CV-101 Garage Conveyor - Wiring Print (DRAFT)

FLM-WD-CV101 Rev A | IEC | 2026-07-02

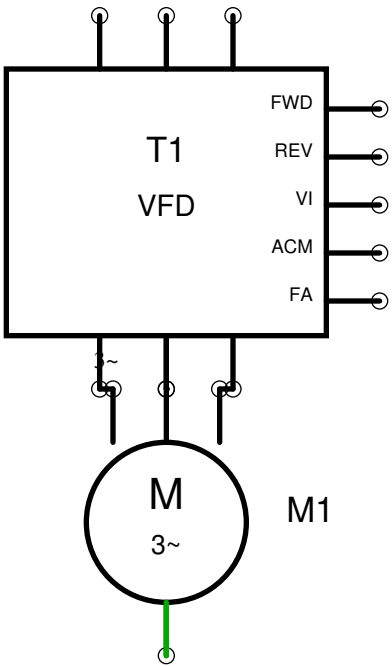
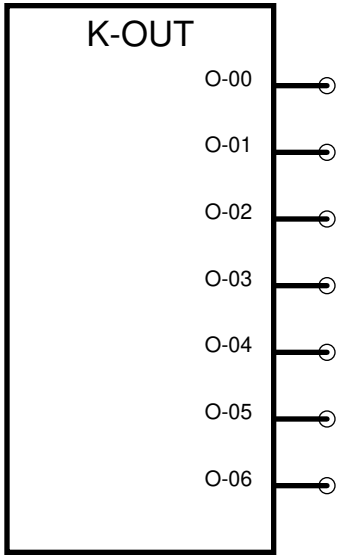
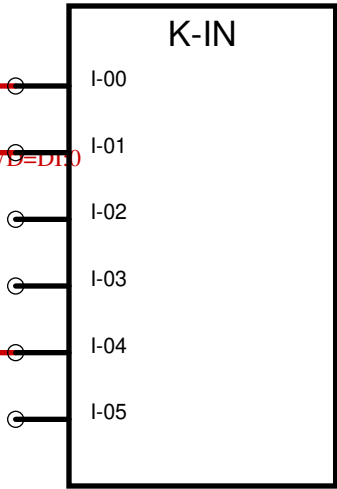
1. DRIVE UNDERSIZED: GS11N-20P2 0.25HP/1.8A out vs motor 1HP/3.8A FLA -> overcurrent ceiling ~1.8A (drive), not 3.8A.
2. SUPPLY: 1-phase 200-240V per GS10 nameplate (DC bus ~320V). R/S/T landing + contactor NOT photographed.
3. CONFIRMED (not drawn - no RJ45 symbol): RS-485 Modbus RTU - Micro820 D+/D-/G <-> GS10 RJ45 (purple).
4. GAP: PLC outputs O-00..O-06 loads UNVERIFIED - no photo maps outputs to loads.
5. GAP: GS10 power terminals R/S/T (in) & U/V/W (out) UNVERIFIED - covered by caution label.
6. GAP: E-STOP dual-channel -> PLC inputs (I-02/I-03?) NOT label-confirmed - shown unwired.
7. GAP: Photo-eye PE-101 -> I-05 PROPOSED, not confirmed - shown unwired.
